SUBJECT: SR 539 MP 0.01 to MP .03 XL 3279
Spring Creek Fish Passage Retrofit
Draft Hydraulic Summary Transmittal

HYDRAULIC SUMMARY

Spring Creek – Fish Passage Retrofit
MP 0.01 TO MP 0.03

SR Spring Creek Twin Culverts Fish Passage Retrofit Design.

FIG 3

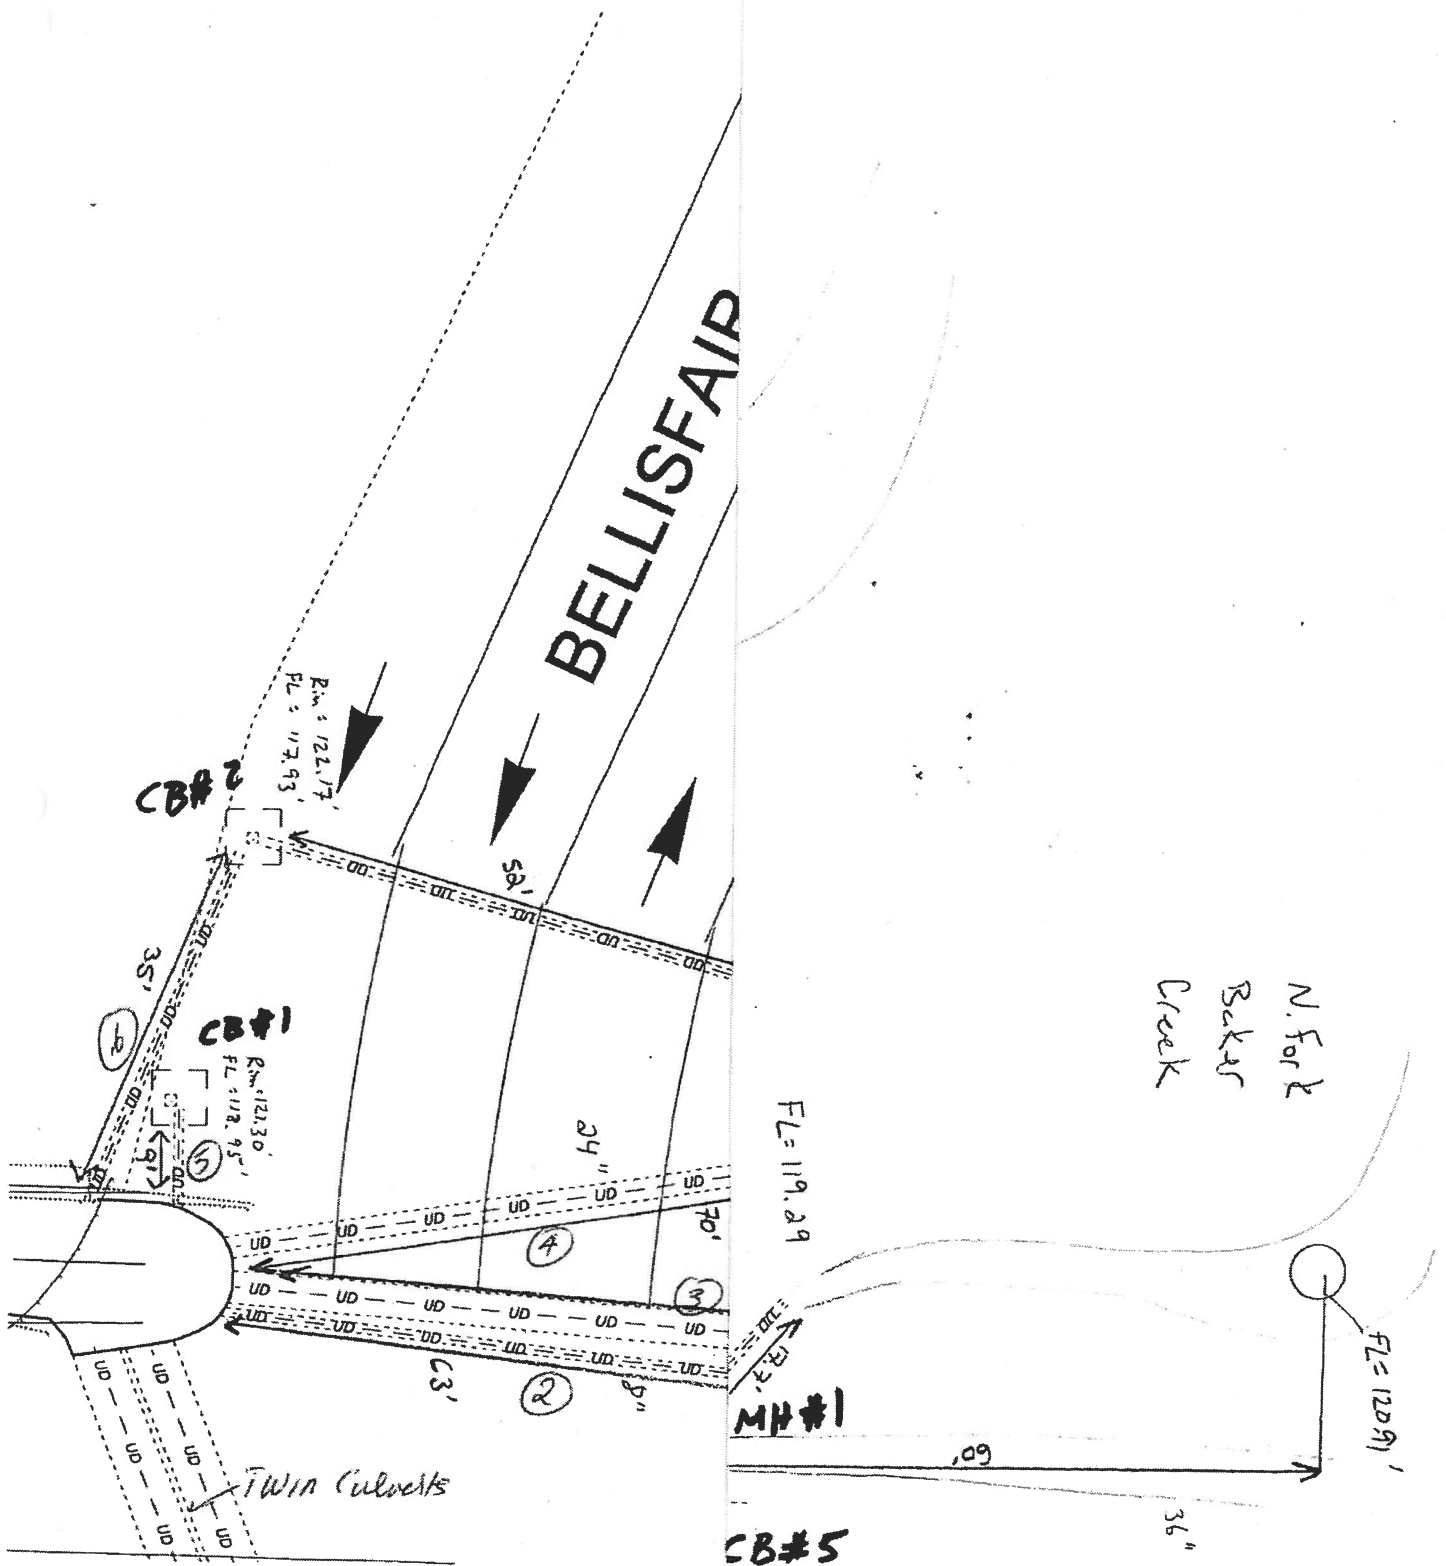
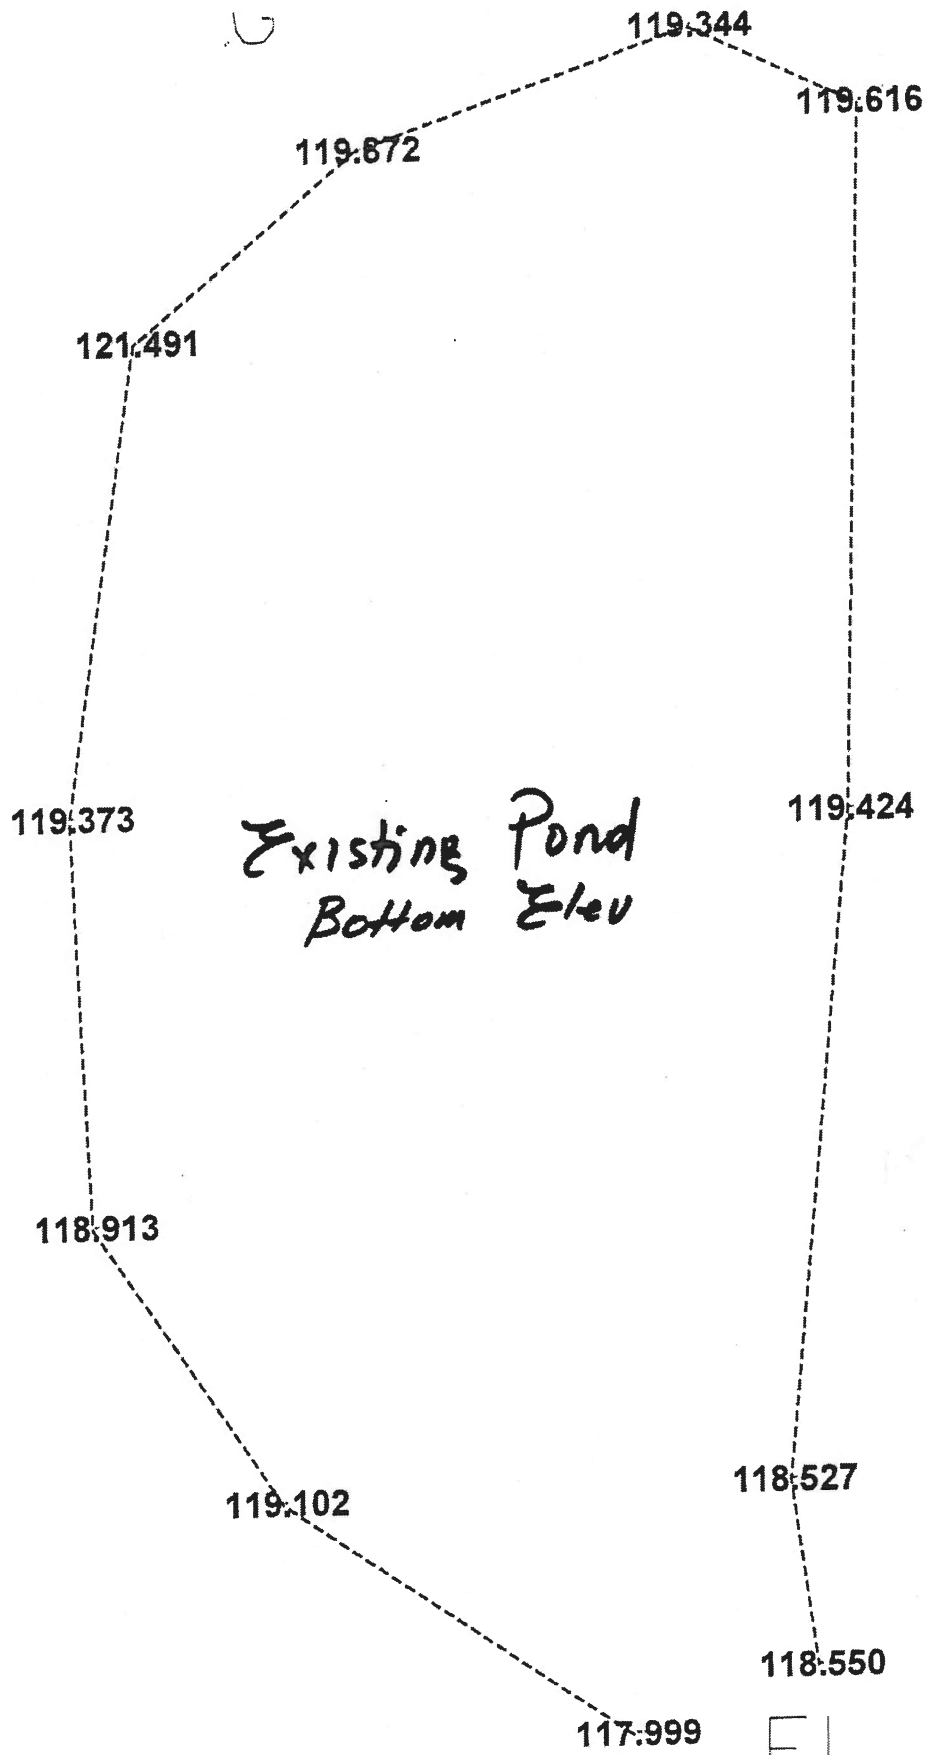
Upstream of the North Fork Baker Creek Tributary Culvert the lowest elevation of the pond bank is 123.07 feet (Fig 3). Therefore, flooding will occur above this elevation. Any backwatering into the existing pond will affect the functionality of the pond and also may create a liability to WSDOT for any property damage and/or environmental impacts due to the flooding.

In the vicinity of the North Fork Baker Creek inlet, the rim elevation of CB #5 (Fig 3) located on the west side of SR 539 is 123.58 feet. Overflow through this CB may flood SR 539.

Fig 2

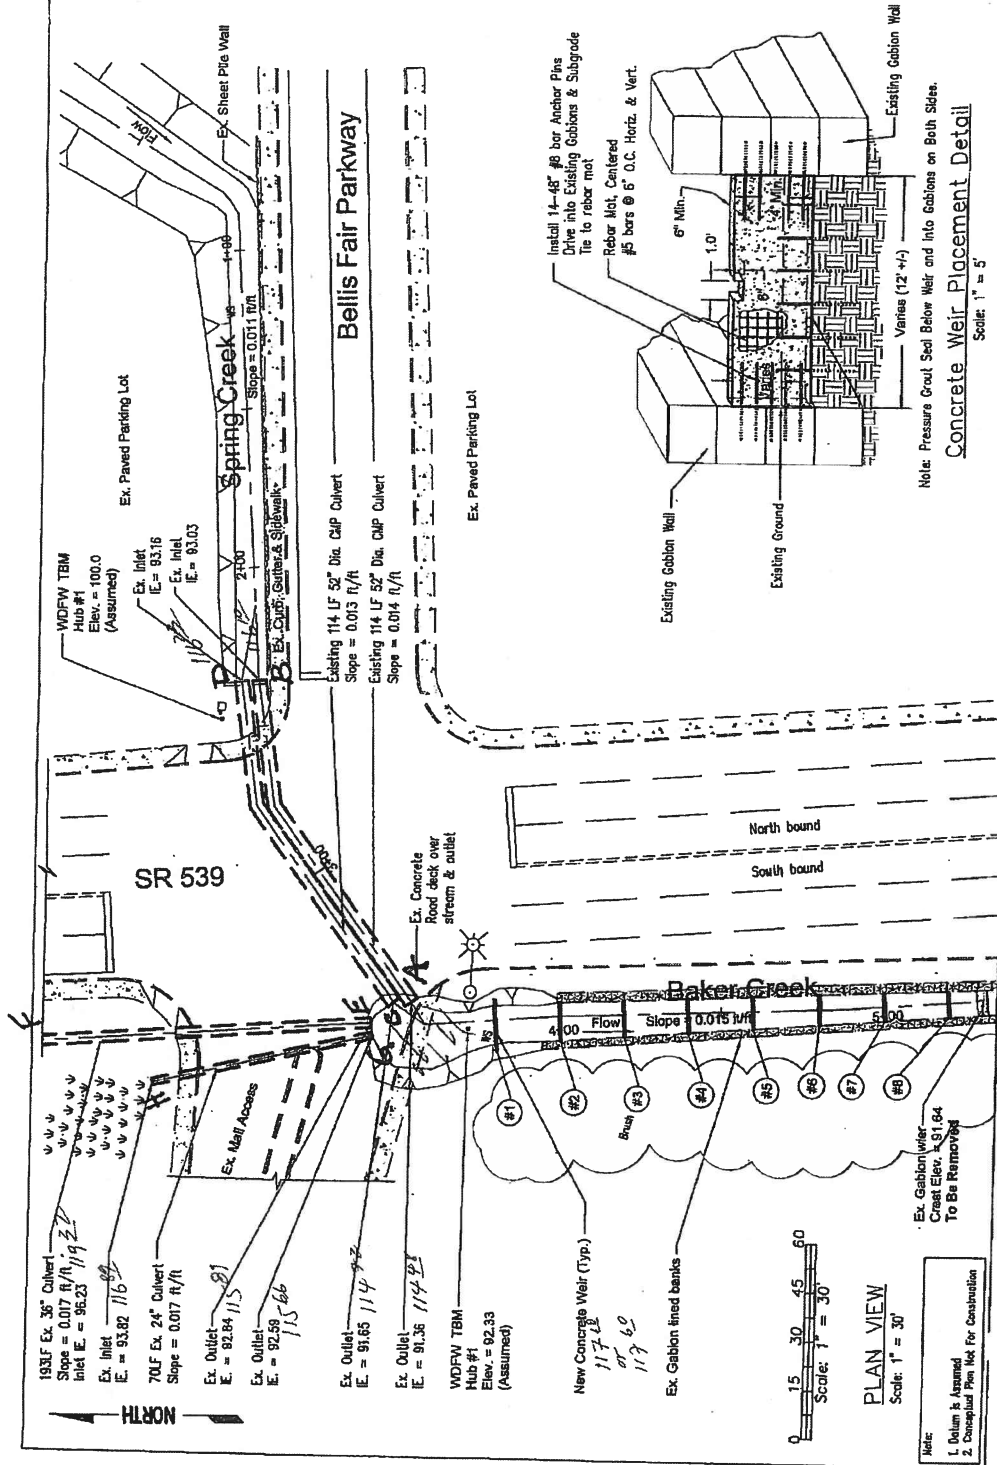
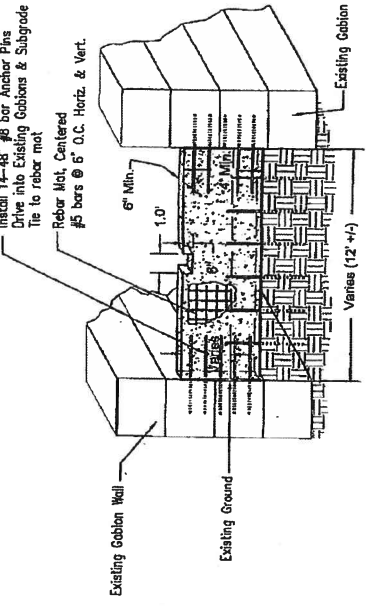
Upstream of the Spring Creek Culverts bank overtopping has been estimated to start at elevation 123.23 feet (adjusted for WSDOT's datum). This was determined by Don Ponder (WDFW) in his January 10, 2007 memo to Chris Detrick by adding 30" to the crown elevation to the right bank culvert inlet. i.e. $116.23 + 4.5 + 2.5 = 123.23$) see Fig 2 point D. If overtopping occurs the adjacent strip mall area will be flooded.
